Assessment of the Currently Proposed Post-Mining Water Level in NHCS Quarry Pit

August 22, 2017

Michael J. Byle, P.E., D.GE, F.ASCE and
Tetra Tech, Inc.
One Oxford Valley, Suite 200
Langhorne, PA 19047

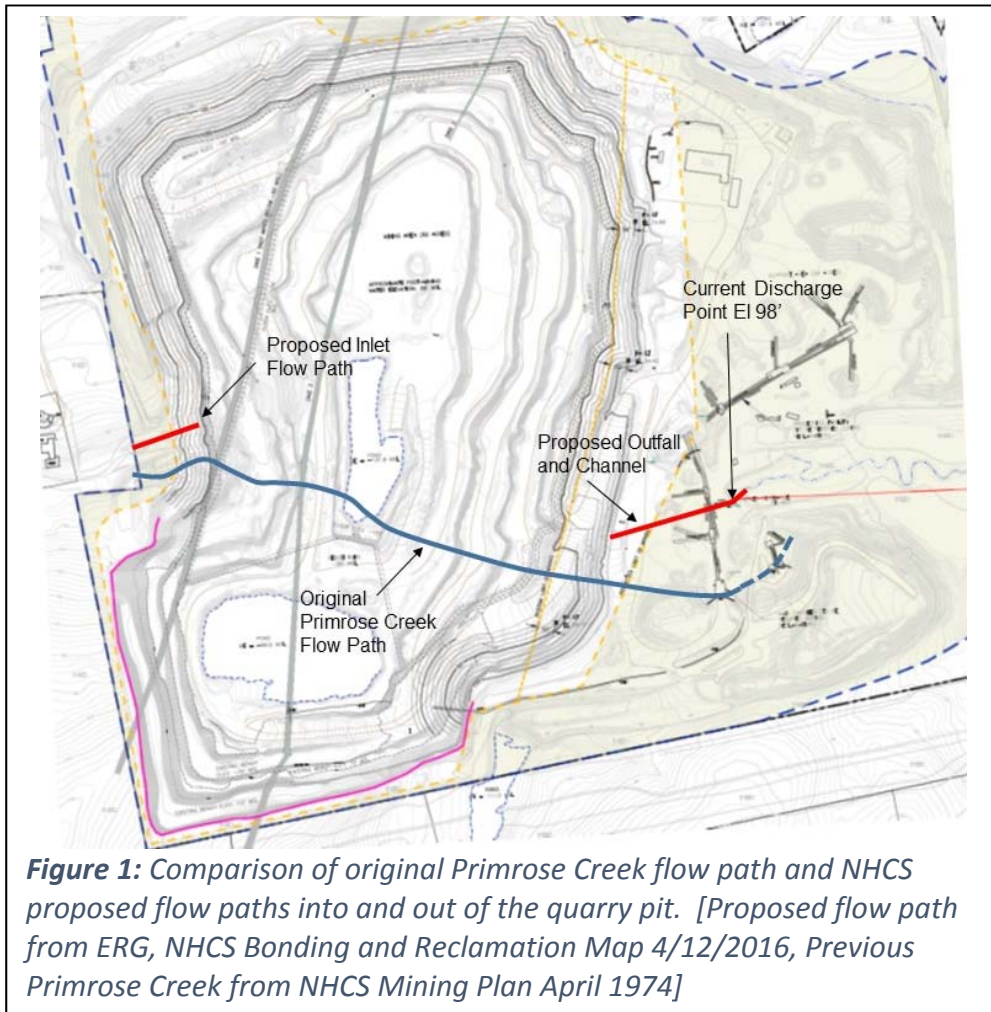
all, of the campus—although it is possible that the groundwater could cover the top of rock in certain places at certain times. However, with a final pool water level of +106' MSL, groundwater levels are likely to range from approximately +106' MSL on the east side of campus to approximately +120' MSL on the west side of campus. In this scenario, the groundwater would be positioned above bedrock across a majority of the campus—a vast improvement over the current situation and considerably better than the outcome with a +98' MSL water level in the quarry pit.

Additionally, raising the final post-mining water level will further reduce the head differential and velocity of the groundwater, which in turn will reduce the subsurface erosion of regolith and help stabilize the soil and rock underlying the campus. Here, too, it is beneficial for the groundwater to be allowed to rise as high as possible. Thus, allowing the water in the quarry pit to rise beyond +98' MSL to +106' MSL will make an appreciable difference.

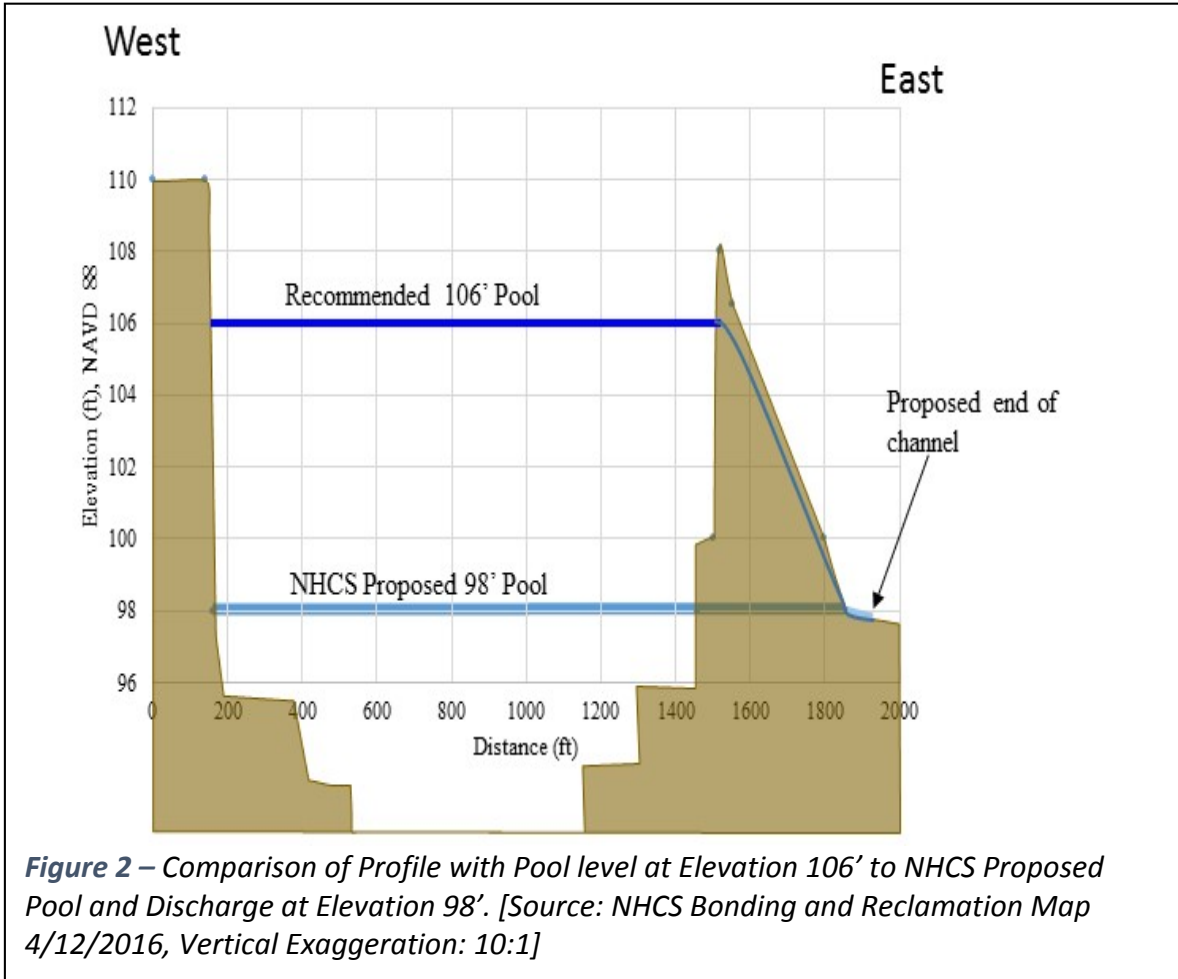
Further complicating NHCS’s current plan is the fact that the path of the proposed channel is not yet flat. As shown in Figure 1, the current rim of the eastern quarry wall in the location of NHCS’s proposed outfall is at approximately +108’ MSL—a full ten feet above the proposed outfall and final water level. The ground slopes down from the rim, reaching the proposed discharge point at +98’ MSL approximately 380 feet to the east. Thus, under the current plan, not only will the final water level be artificially suppressed at +98’ MSL—well below the current capacity of the quarry pit—but significant earthwork must be undertaken to achieve an unnecessary and counterproductive end. Specifically, a 10-foot deep notch must be cut into the eastern rim in order to accommodate an outfall at +98’ MSL, and the remainder of the 380-foot channel will need to be graded in order to create the flat channel NHCS has proposed. This, too, will result in a highly-engineered channel that is dramatically different from the original streambed. Once again, we have not seen any details regarding how NHCS plans to accomplish this task.

will require far less work to construct,⁴ and will be more stable over time. Moreover, this channel will much more closely resemble natural conditions and the grade, size, and elevation of the original streambed. A cross section comparing this level with that currently proposed by NHCS is presented in Figure 2.

By contrast, if the water level is allowed to rise to +106’ MSL, gravity will convey water from the outfall to the designated discharge point via a channel with a natural gradient. Such a channel
